Access Compliance Report Public Rights-of-Way (Curb Ramps)

Main Street: EARLHAM_ST Cross Street: FAIRHAVEN_AVE Location: NE

ADA ID: RPRK220127141327 Ramp Type: Type 4 - Parallel Initial Pass/Fail: Fail Overall Compliance: No Severity Score: 2

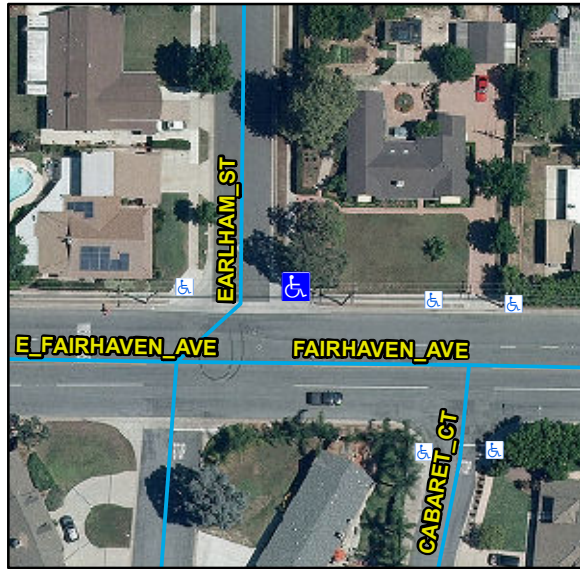
Compliance	Description	Data	Compliance	Description	Data
N/A	Ramp Length LT (in)	106	N/A	Ramp Length RT (in)	112
Yes	Ramp Width LT (in)	86	Yes	Ramp Width RT (in)	86
Yes	Ramp Run Slope LT (%)	5.3	Yes	Ramp Run Slope RT (%)	5.3
No	Ramp Cross Slope LT (%)	3.2	No	Ramp Cross Slope RT (%)	2.9
N/A	Landing Present	N/A	N/A	DWS Provided	N/A
N/A	Landing Length (in)	N/A	N/A	DWS Contrast	N/A
N/A	Landing Width (in)	N/A	N/A	DWS Length (in)	N/A
N/A	Landing Run Slope (%)	N/A	N/A	DWS Full Width	N/A
N/A	Landing Cross Slope (%)	N/A		DWS Offset Type	N/A
N/A	Landing Movement Obstructed?	N/A	N/A	DWS Offset Left (in)	N/A
	Landing Movement Type	N/A	N/A	DWS Offset Right (in)	N/A
N/A	Landing Shared	N/A			
N/A	Clear Space	Yes			
N/A	Clear Space To Crosswalk (in)	N/A			
N/A	Marked Crosswalk 1	No	N/A	Marked Crosswalk 2	No
	Crossing 1 Direction	W		Crossing 2 Direction	S
	Marked Crosswalk 1 Width (in)	N/A		Marked Crosswalk 2 Width (in)	N/A

Remove & Replace Curb Ramp With Two New Directional Ramps or Equivalent.
